CHANGE ORDER NO. 1 - Project #221014

Issuant Date: July 29, 2022	Owner's File No. (P.O.): 21121073-000
Contractor: C3 Construction Services Inc.	Contract For: Cooper Center Roof Replacement

2021 RESERVOIR PARK
 COOPER COMMUNITY
 CENTER ROOF
 REPLACEMENT
 200298 CREIGHTON AVE.,
 FORT WAYNE IN, 46803

TITLE: NORTH, SOUTH, EAST, WEST - ELEVATIONS

1 NORTH ELEVATION
SCALE 1/4" = 1'-0"

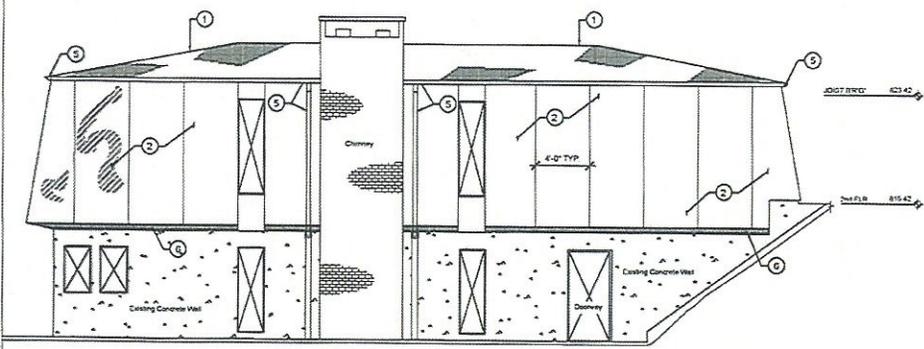
Roof substrate to be replaced with new to match existing.

2 SOUTH ELEVATION
SCALE 1/4" = 1'-0"

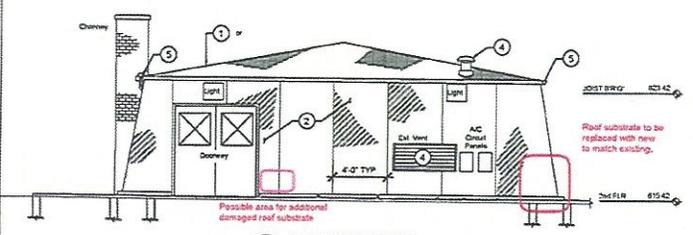
Roof substrate to be replaced with new to match existing.
